SIB 64 04 16

Water Ingress In Footwell Area From A/C Condensate Drain

This Service Information Bulletin (Revision 2) replaces SI B64 04 16 **dated February 2020**.

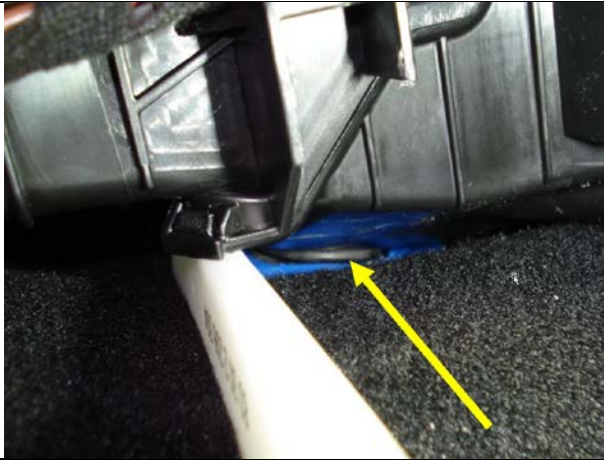
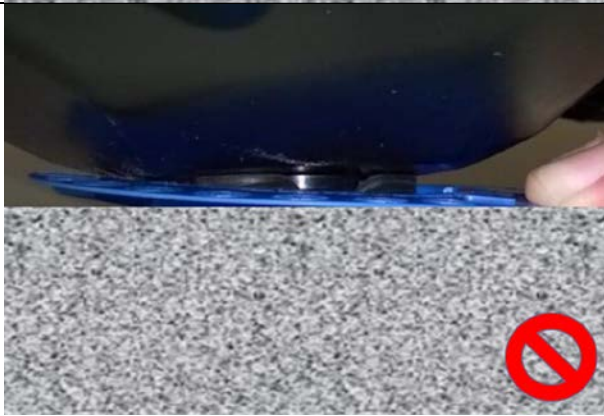
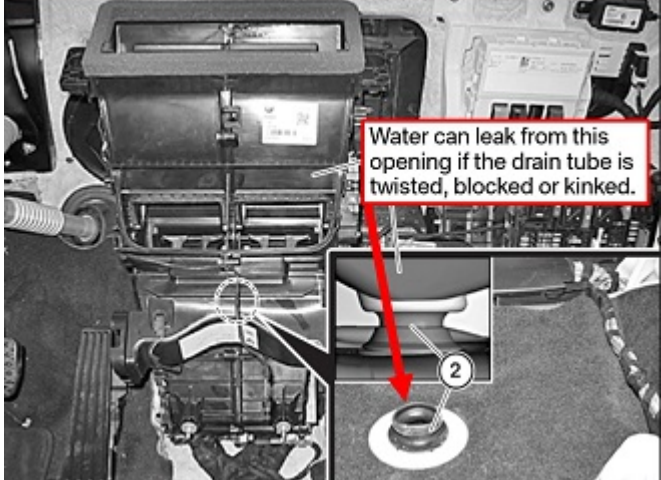
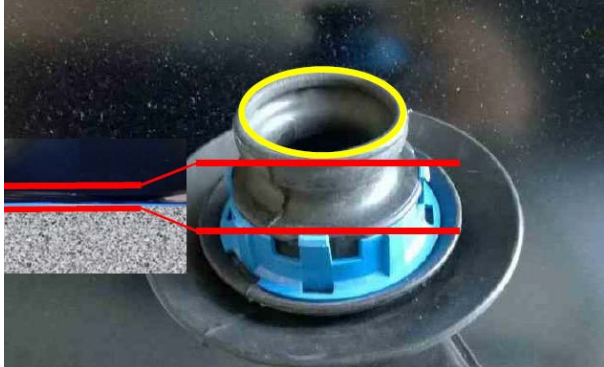
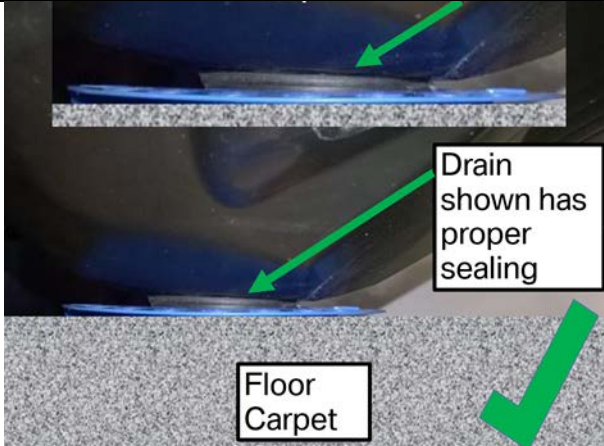
<p>1. Press carpet down using a nylon lever to expose drain.</p>
	<p>2. If drain is twisted or deformed it must be replaced.</p>
	<p>3. This close up shows drain incorrectly installed.</p>

<p>4. Water leaks can occur in these areas causing the molding smell from carpet.</p>
	<p>5. Prepare new drain by cutting the lower section approximately 30 mm. This will prevent future blockage.</p>
	<p>6. Before installing new drain, lubricate (silicone spray) top of drain shown by the yellow ring. Make sure the drain is not deformed and install parallel to the floor and carpet.</p>

<p>Drain shown has proper sealing</p> <p>Floor Carpet</p>	<p>7. A correct drain installation is shown.</p> <p>8. Install all removed parts.</p>
---	---
